Kintore to Tealing 400kV Overhead Line

Summary Report on Consultation - Alignment Selection

January 2025

Figure 13 - Proposed Alignment for Location 3: Justinhaugh

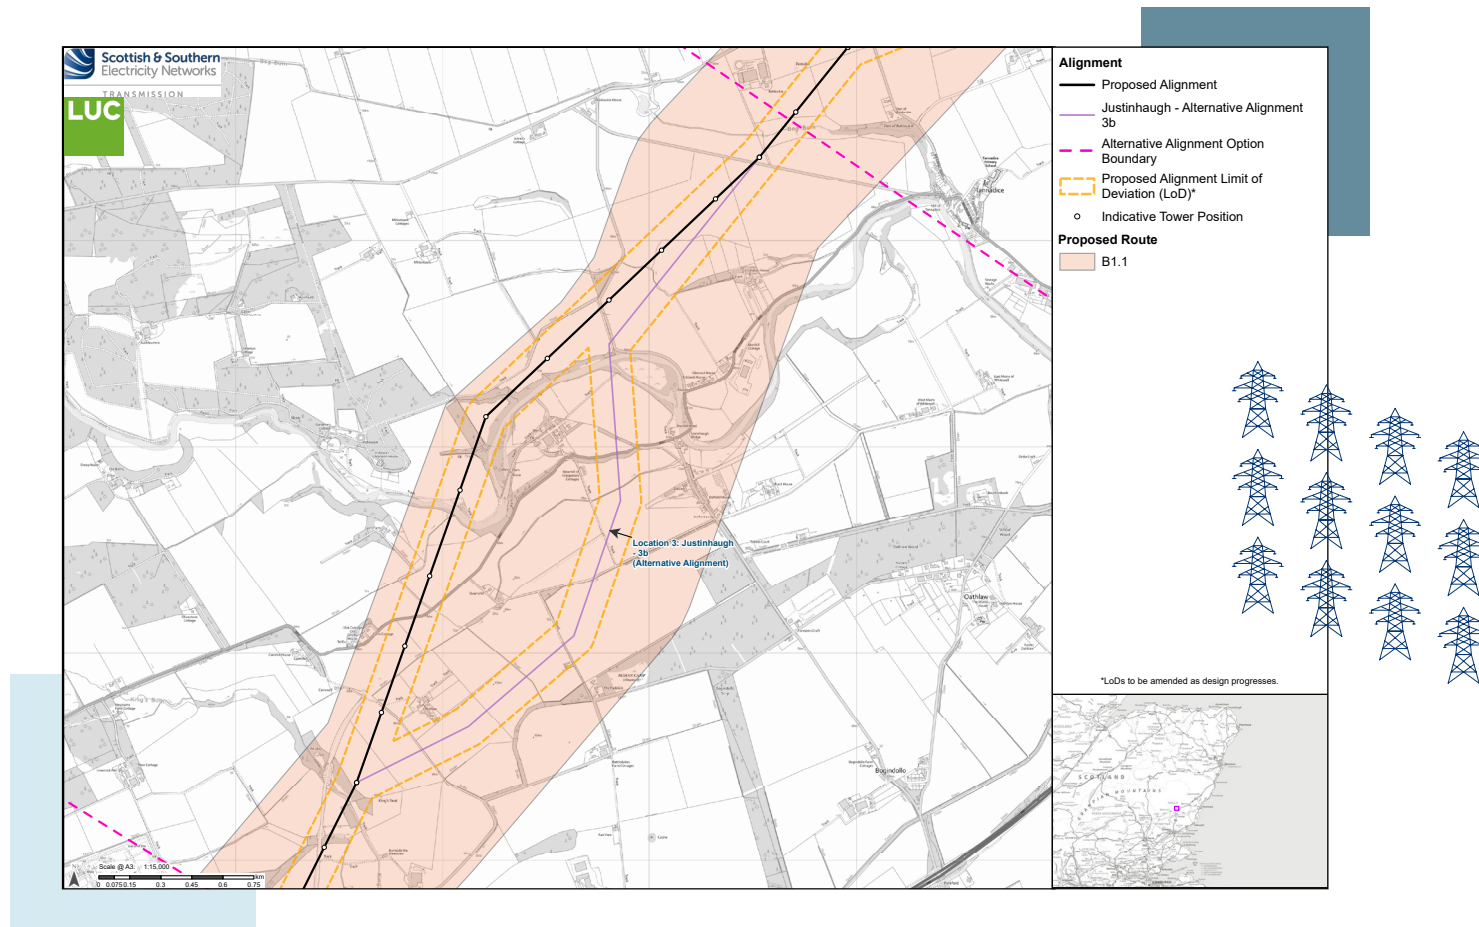
- Any overhead line along Alternative Alignment 3b would be seen from the A90 and nearby houses, this was not the case with Potential Alignment 3a.
- Concerns were raised from ACAS regarding the potential to impact cultural heritage features including Battledykes Roman Camp and Battledykes Cairn, and respondents noted a preference for Potential Alignment 3a.
- The crossing of the river by Alternative Alignment 3b was raised as a concern due to flooding issues.
- Particular concerns were raised about the unsuitability of local roads for access, Potential Alignment 3a was considered to be more suitable.
- It was judged by some that Alternative Alignment 3b would have adverse detrimental impacts on farmland and residential properties, with Potential Alignment 3a preferred.

- Respondents felt that fewer homes would be impacted by Alternative Alignment 3b. It was felt that noise impacts from the overhead line during operation could not be mitigated and that SSSEN Transmission's target to site the overhead line no closer than 170m from homes could not be met on Potential Alignment 3a.
- Visual impact on viewpoints in the area of Potential Alignment 3a would be significant; of note would be the impact on the view north to the Glens across the River South Esk. Alternative Alignment 3b would be less detrimental.
- Concerns were raised relating to the crossing of the River South Esk by Potential Alignment 3a, particularly in relation to aquatic ecology, salmon spawning, fishing areas and osprey nesting.

- Proximity to property is considered to be similar for both alternatives and the overhead line will be developed to maintain a target separation distance of at least 170m or more from residential properties and to maintain a minimum distance of 100m where possible, taking account of other land uses.

- There is potential for adverse effects on views and visual amenity from some properties adjacent to both alternatives and these will be assessed further in the EIAR. Alternative Alignment 3b crosses a pronounced area of raised ground north-west of Battledykes which was considered to have particular landscape and visual impacts compared with the Potential Alignment 3a.

- Both alternatives cross the River South Esk which formed a key part of the appraisal of several environmental criteria. The Potential Alignment 3a would span the river and its flood plain with less impact on surface and groundwaters and less potential to impact on the ecological designation compared with the Alternative Alignment 3b.

- Potential Alignment 3a includes some tower locations which involve more challenging topography; however, overall it has been evaluated as being less technically constrained overall than Alternative Alignment 3b.

Having reviewed consultation feedback for this alignment location, including statutory consultee views, on balance it is considered that Potential Alignment 3a remains less constrained overall in relation to the environmental and technical criteria appraised.

In this location we will take **Potential Alignment 3a** forward for the Environmental Impact Assessment and detailed design as our Proposed Alignment, as shown in **Figure 13: Proposed Alignment for Location 3: Justinhaugh**.

Figure 14 - Proposed Alignment for Location 4: Careston

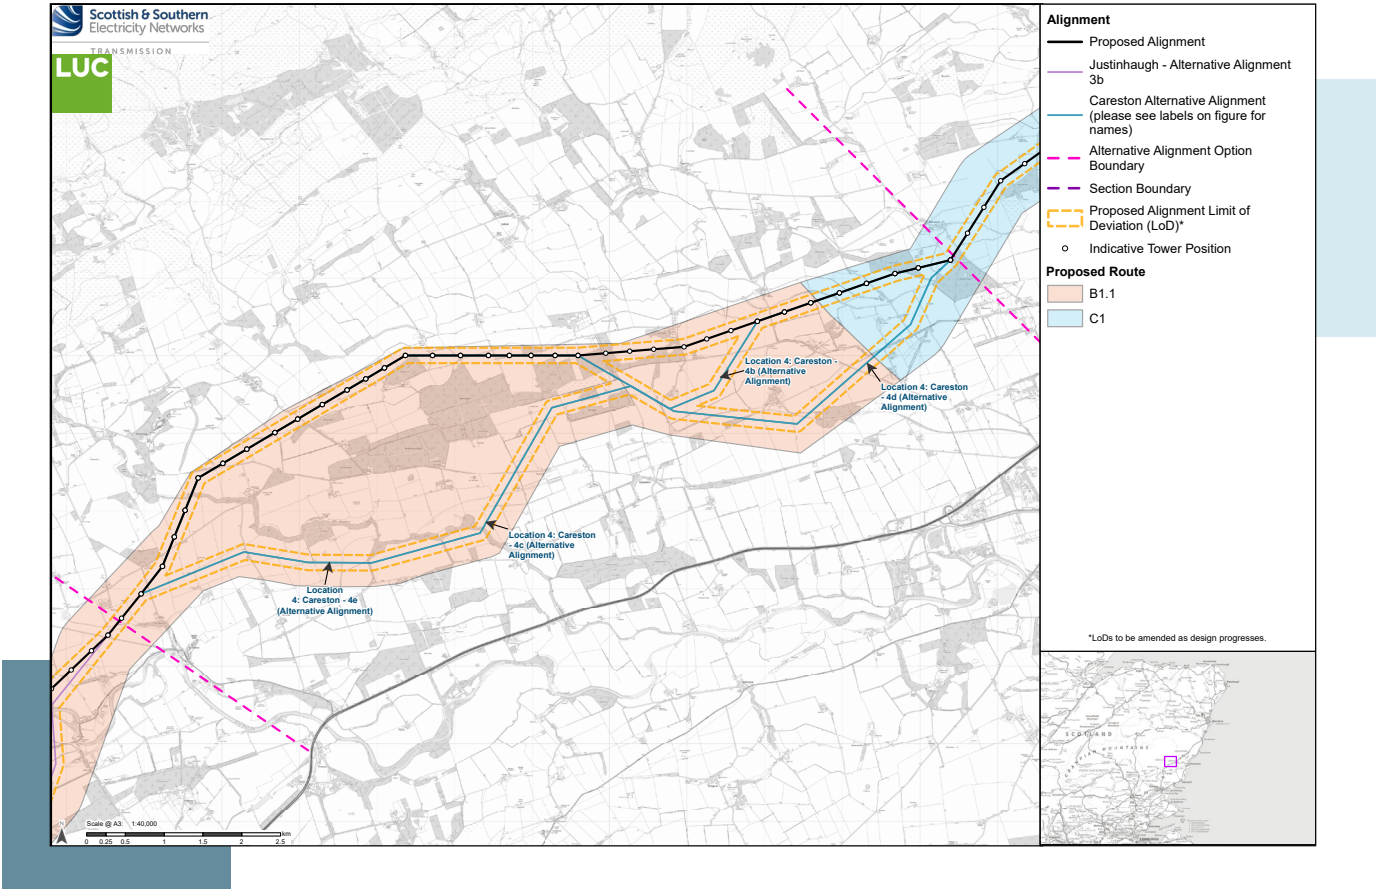
- It was considered that Potential Alignment 4a has less impacts on the environment, residents, properties, and visual amenity compared to the Alternative Alignments.

- Concerns were raised by HES and ACAS regarding impacts on cultural heritage features including Vayne Castle, Vayne Standing Stone and Law of Windsor Cairn. HES confirmed that the Potential Alignment 4a was considered to have least impact.

- Angus Council noted that Potential Alignment 4a was situated within a larger scale landscape and may be more suitable for large structures.
- Some preferred Potential Alignment 4a as it runs in a straighter line and would be better for the environment and the community.

- Potential Alignment 4a was considered to cross poorer quality and flood-prone farmland and therefore was appropriate for an overhead line.
- Potential Alignment 4a and Alternative Alignments 4b and 4d were considered by the Esk DSFB as more preferable for salmon migration.

- It was felt that Alternative Alignment 4b would have less impact on the environment, impacting less woodland and wildlife.
- Alternative Alignment 4b would not cause as much disruption and could traverse poorer agricultural ground, areas that flood and recent conifer planting.
- Some had a preference for Alternative Alignment 4b due to fewer impacts on properties.

- Alternative Alignment 4c would have less impact on the environment destroying fewer woodland areas and wildlife.
- Some considered that Alternative Alignment 4c would have less impact on residents, properties and the landscape.
- Alternative Alignment 4c has poorer quality and flood-prone farmland and lends itself more to an overhead line.
- Alternative Alignment 4c would help protect the River Cruick and its valley.

- Fewer people would be affected by Alternative Alignment 4d.
- Alternative Alignment 4d would have less impact on valuable woodland areas and wildlife, and would be better screened by trees.
- It was felt that Alternative Alignment 4d poses the lowest risk to the mains gas pipeline in the area.
- Alternative Alignment 4d would not cause as much disruption as it runs through agricultural ground and recent conifer planting.
- Alternative Alignment 4d would help protect the River Cruick and its valley.

- Alternative Alignments 4e was the most direct option.
- It was felt that Alternative Alignment 4e would have less impact on valuable woodland areas and wildlife.
- Alternative Alignment 4e would have less of an impact on residents and the landscape.

- Proximity to property has been reconfirmed and the Potential Alignment 4a is constrained by a slightly greater number of properties than the other alternative alignments. However, it provides the opportunity to maintain a greater distance between the overhead line and residential properties, particularly around the groups of properties in the area of Careston. The overhead line will be developed to maintain a target separation distance of at least 170m or more from residential properties and to maintain a minimum distance of 100m where possible, taking account of other land uses.

- There is a clear difference in landscape and visual constraints with Alternative Alignments 4c and 4e least preferred due largely to their alignment over a prominent and elevated ridge feature. Alternative Alignment 4b is considered to be more visually constrained than Alternative Alignment 4d and the Potential Alignment 4a due to its proximity and wrapping around receptors at Montboy.

- All of the alternative alignments would require some loss of woodlands including areas associated with riparian planting at watercourse crossings and the woodlands at Duns Wood and Lochty Wood. The Potential Alignment 4a would intersect part of Lochty Wood and is more constrained in this location than the comparable Alternative Alignments 4b and 4d however it is considered that groundwater dependent habitats associated with the woodland area could be avoided or mitigated. Alternative Alignment 4d also intersects part of Barrelwell Bog Local Nature Conservation Site (LNCS) which can be avoided with the Potential Alignment 4a.

Having reviewed consultation feedback for this alignment location, including statutory consultee views, and following further survey and design development, on balance it is considered that Potential Alignment 4a remains least constrained overall in relation to the environmental and technical criteria appraised.

In this location we will take **Potential Alignment 4a** forward for the Environmental Impact Assessment and detailed design as our Proposed Alignment, as shown in **Figure 14: Proposed Alignment for Location 4: Careston**.

- The Potential Alignment 4a and Alternative Alignments 4b and 4d are considered to be less constrained than Alternative Alignments 4c and 4e in relation to the setting of designated cultural heritage sites with no material difference between them in terms of their potential for effects on archaeology.

- All of the alternatives need to cross the Noran Water however there is no material difference in the level of constraint for flood risk or in the potential to impact water quality of the watercourses during construction.

Figure 15 - Proposed Alignment: Section C

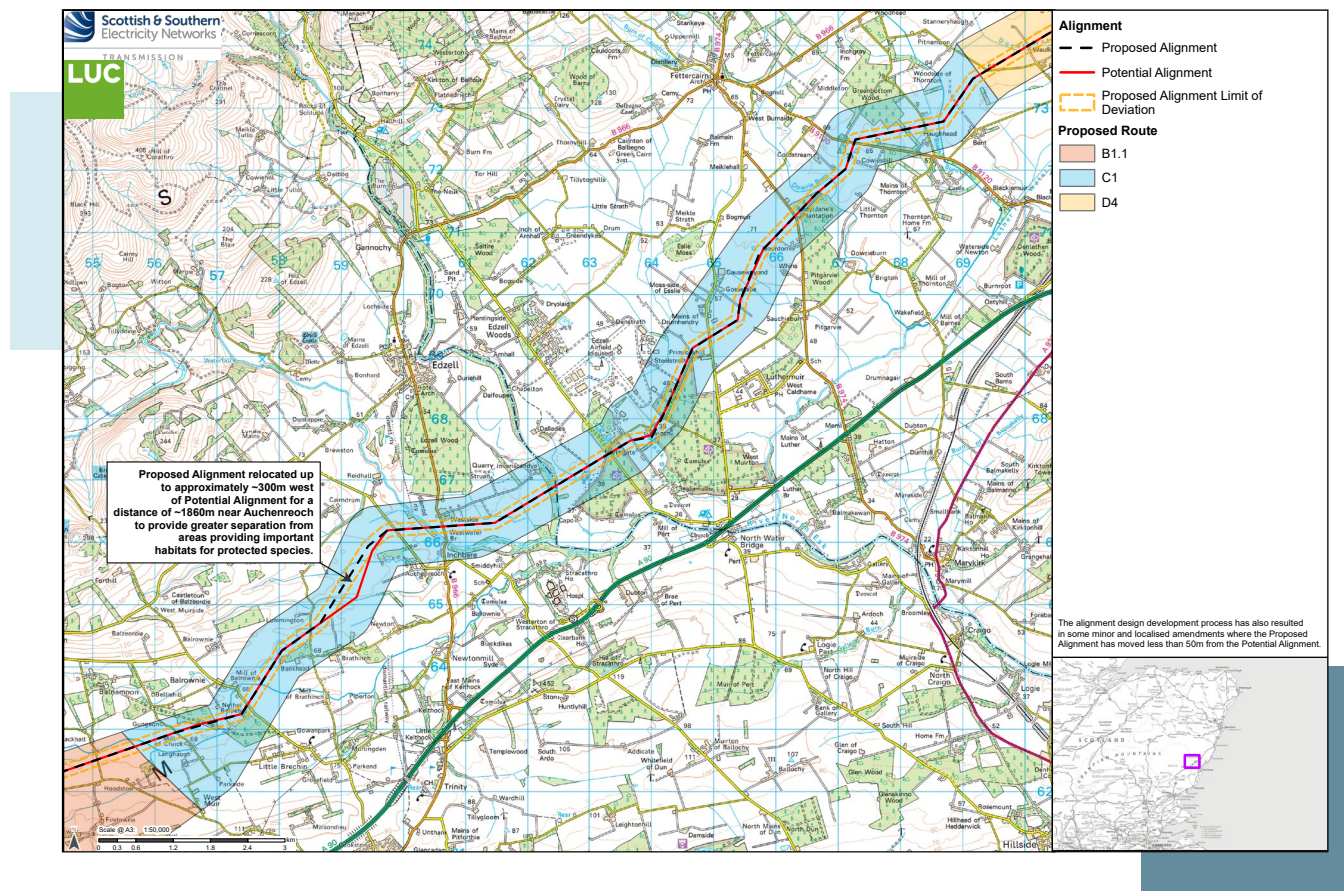
- Community benefits: Suggestions included support for new cycle paths and tree planting to soften the visual impact of the proposed overhead line specifically around Fettercairn.

Having reviewed the consultation feedback for Section C a small change has been made to the Potential Alignment in one location as described below. No other significant changes to the Potential Alignment are proposed.

At Auchenreoch the alignment has been refined to provide greater separation of the overhead line from an area providing habitat for protected species.

In Section C we will take the Potential Alignment forward for the Environmental Impact Assessment and detailed design as our Proposed Alignment, as shown in **Figure 15: Proposed Alignment - Section C.**

Figure 21 - Proposed Alignment for Location 8: Echt

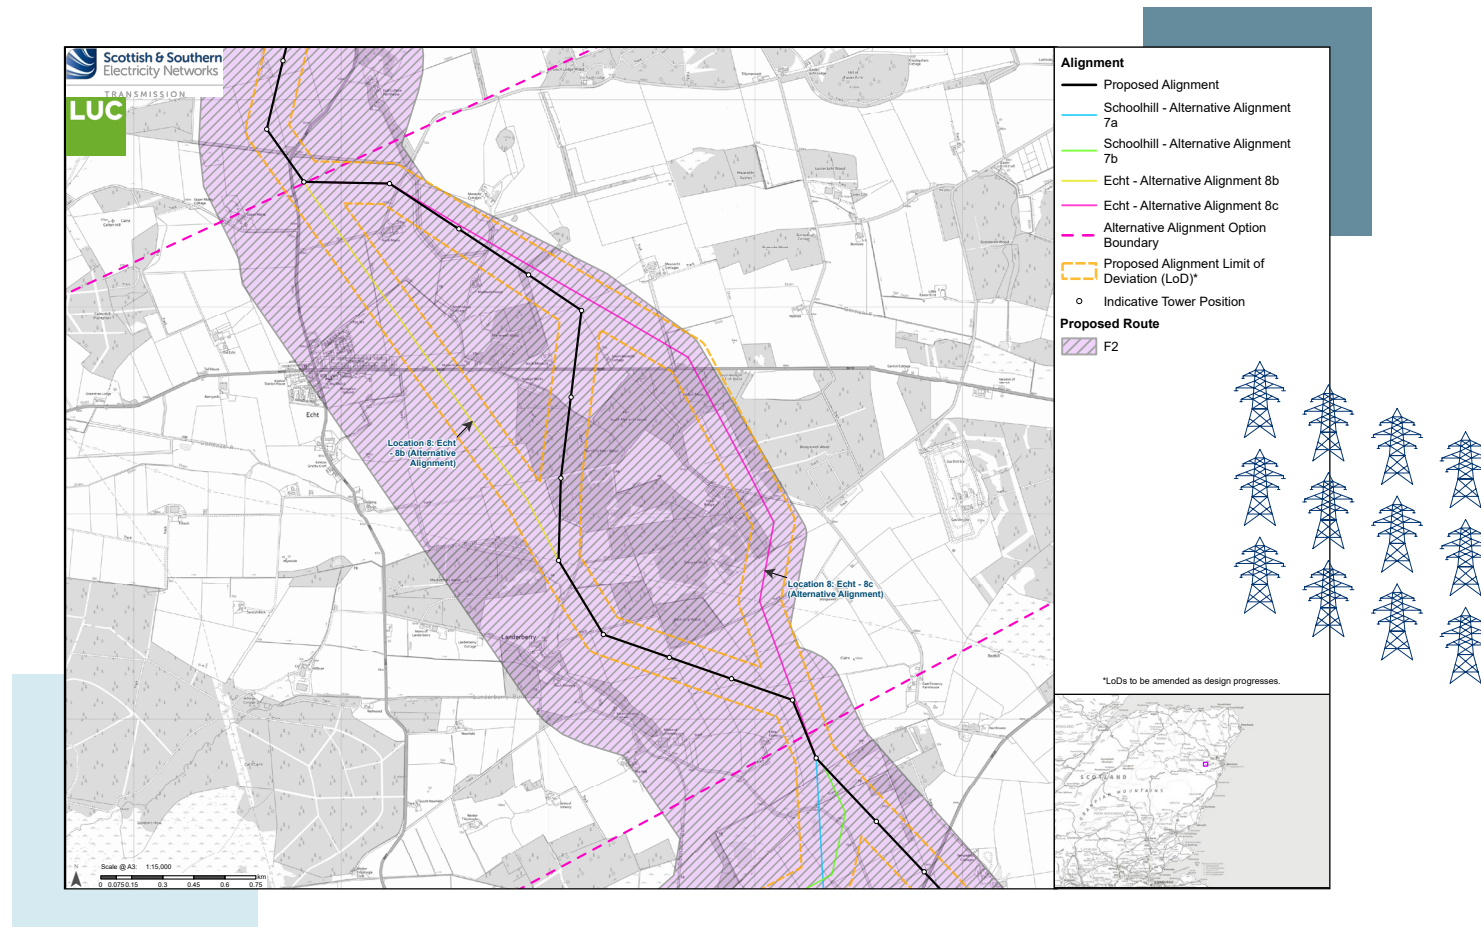
- Alternative Alignment 8b would be unacceptable to some Echt residents as it passes too close to Echt village, the primary school and playing fields, and the 170m separation distance could not be achieved, core paths and planning application site boundaries are also being crossed. There was a preference expressed for either Potential Alignment 8a or Alternative Alignment 8c.
- Potential Alignment 8a would ensure the route does not encroach on the Dunecht House GDL.
- It was considered by some that Potential Alignment 8a and Alternative Alignment 8c would benefit from greater visual screening from the existing trees which would mitigate the impact to the village of Echt.
- Concerns were raised by ACAS and HES regarding the potential to impact cultural heritage features including East Finnercy Cairn, with a preference for Potential Alignment 8a or 8b.

- Concerns were raised about Alternative Alignment 8b near Echt, and a preference for Alternative Alignment 8c as it would minimise visual impacts and avoid areas with planning permission.
- Some respondents suggested Alternative Alignment 8c was the least disruptive alternative.
- Feedback indicated that Alternative Alignment 8b would be unacceptable to some Echt residents, with a preference for Potential Alignment 8a or Alternative Alignment 8c.
- It was felt that Alternative Alignment 8c would avoid the fields that support large bird populations.
- Alternative Alignment 8c would keep the overhead line as far from the school, village and fields used by the community as possible.
- Alternative Alignment 8c was considered by some as the least impactful to the community and recreational space.

In this location we will take **Potential Alignment 8a** forward for the Environmental Impact Assessment and detailed design as our Proposed Alignment, as shown in **Figure 21: Proposed Alignment for Location 8: Echt**.

- All of the alternatives have potential for adverse effects on visual amenity. The Potential Alignment 8a and Alternative Alignment 8c may compromise visual amenity experienced from the wider landscape where the overhead line crosses an area of elevated landform. In comparison, Alternative Alignment 8b would compromise visual amenity experienced by a large number of people at the settlement of Echt as the overhead line would lie within close proximity to this settlement.
